## PLANNING COMMISISON SITE PLAN – COMPATIBILITY VARIANCES ONLY

**CASE NUMBER:** SP-2021-0102C      **PC HEARING DATE:** April 12th, 2022

**PROJECT NAME:** 1400 Cedar Ave

The applicant is requesting a waiver from § 25-2-1063. The site is subject to a 25' compatibility setback. The proposed development is encroaching into the 25' compatibility setback on the north and west property lines for the residential units. The units are at least 5' from the property line but within the 25'.

### Exterior Elevations

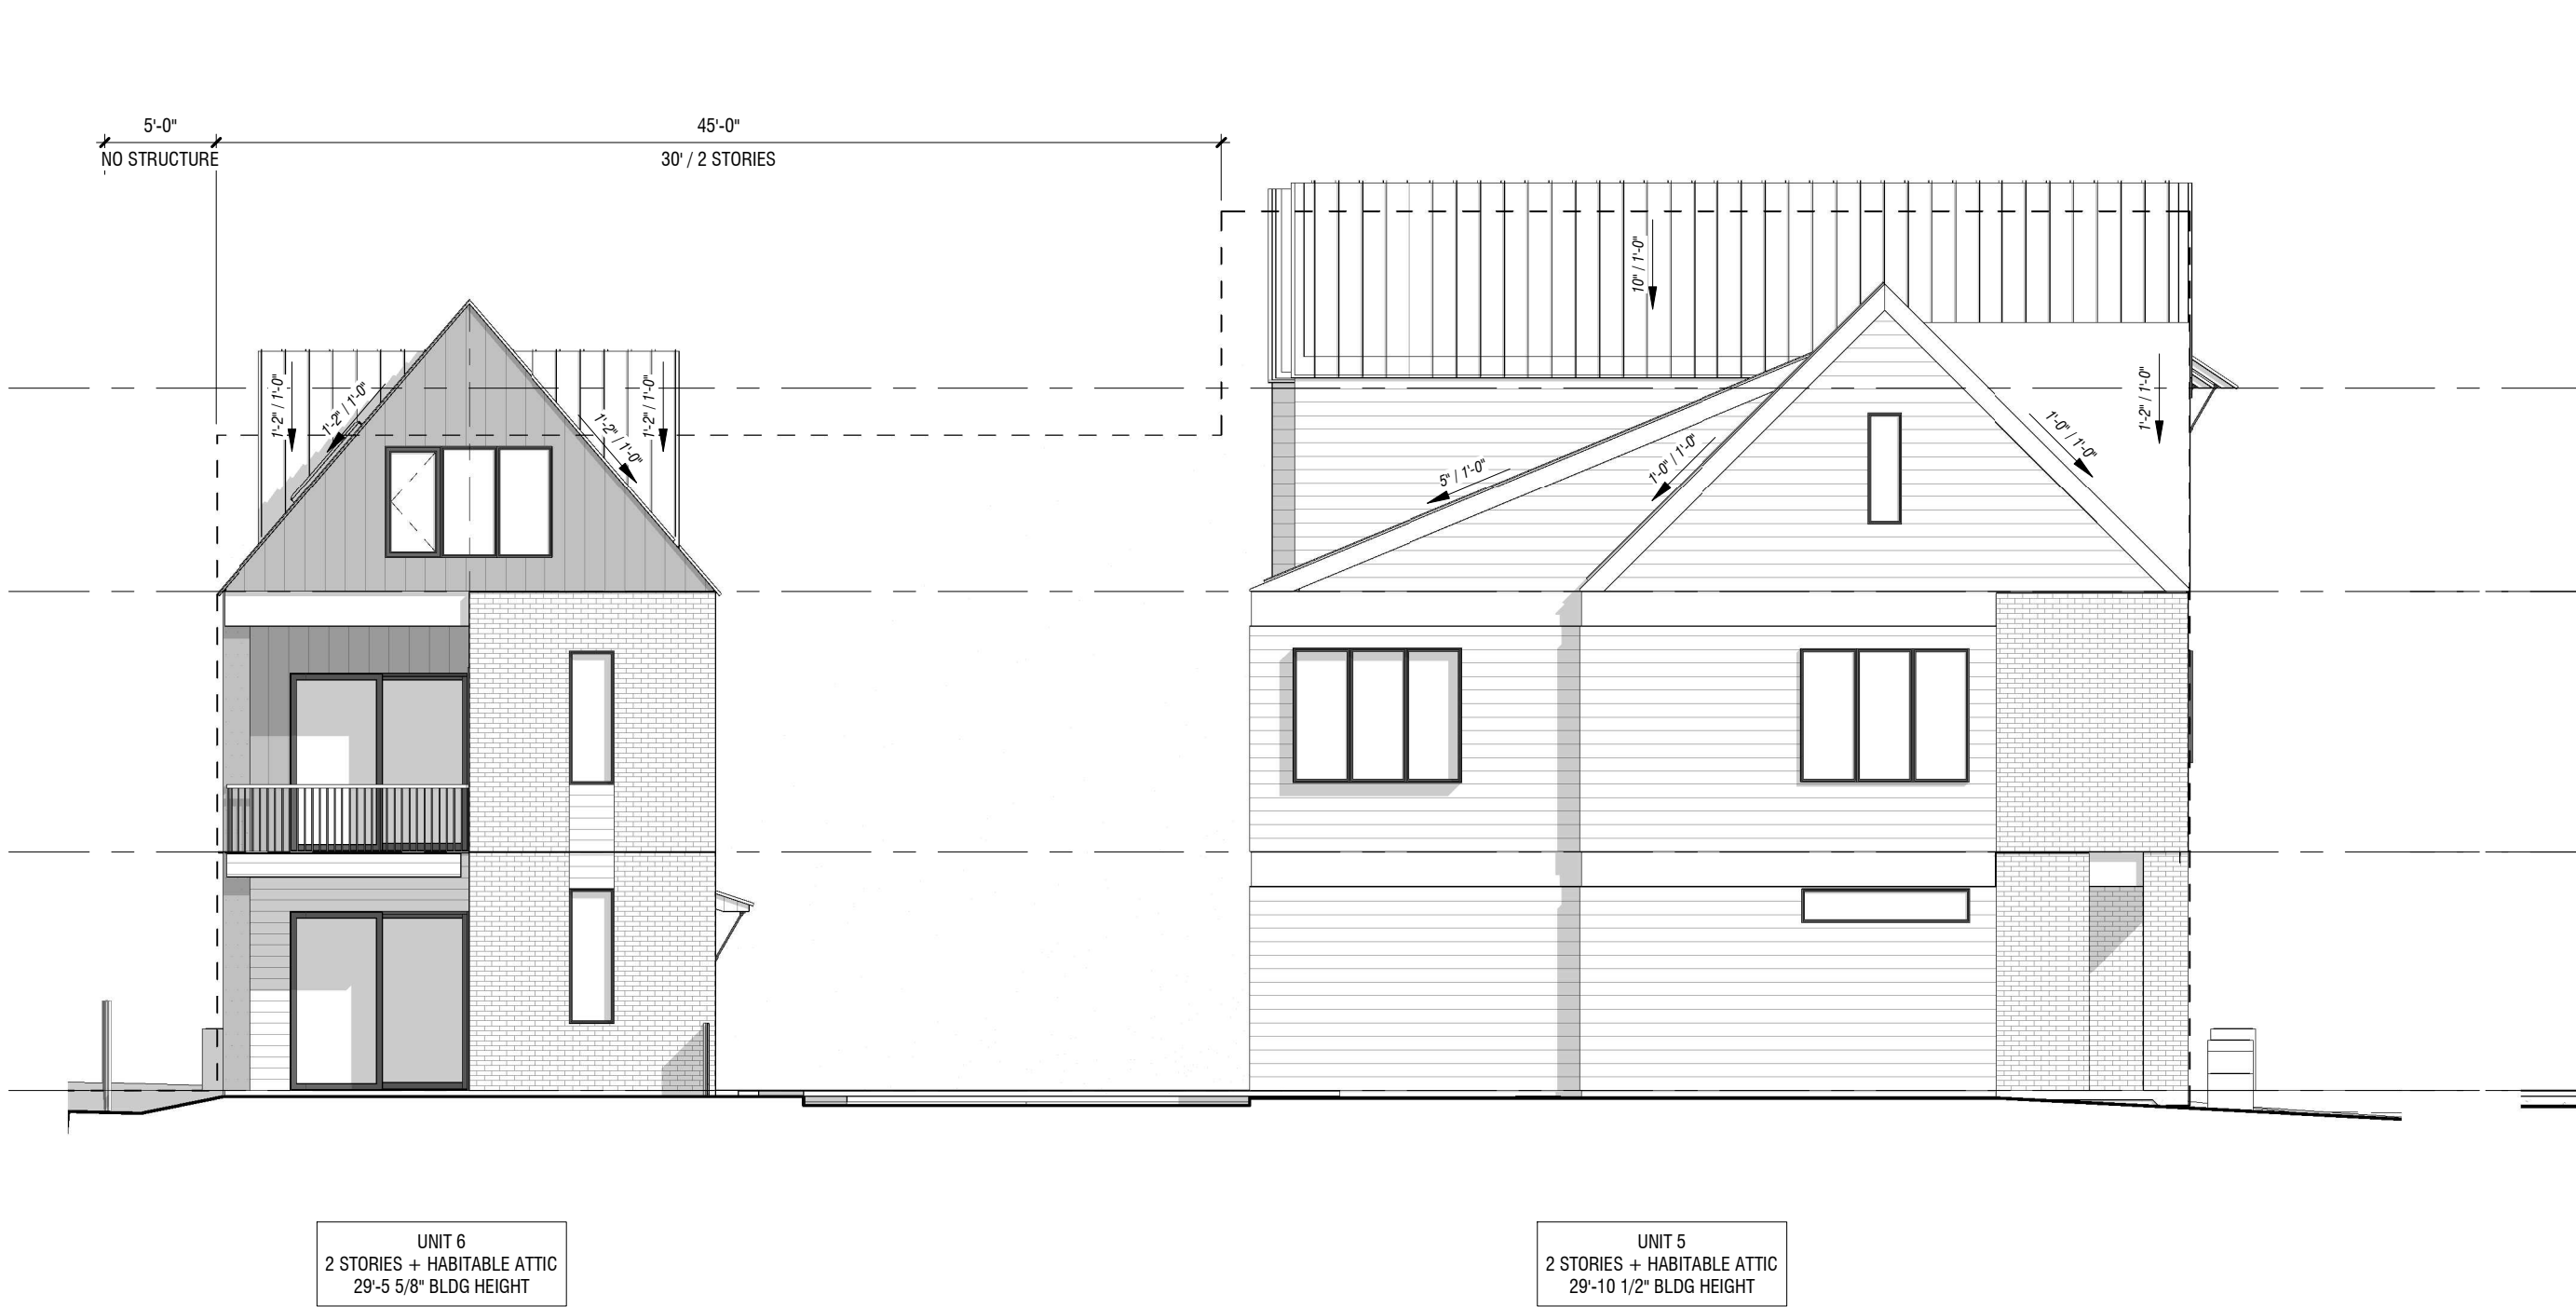
Hi Zack- Thanks for the explanation. As for the height, the exhibit seems to clearly show that they are exceeding the compatibility tent- see below. What am I missing? Thanks,

No problem, David. Height is measured differently for different types of roofs. Since these are gabled, it's measured from the average of the highest and lowest points of the roof or the highest and lowest points of the dormer, whichever is higher. The part of code that outlines how height is measured is 25-2-SubF - Article 3.4.1. So even though the highest point of the roof may be higher than the regulation height, it can still comply as long as the average is below the regulation height. Let me know if you have any more questions.

You are correct that this waiver is only for compatibility setbacks. The proposed development complies with the compatibility height regulations - this is shown in the background materials. I do realize that it's fairly nitty-gritty so let me know if you'd like to have a call to discuss it in more detail.
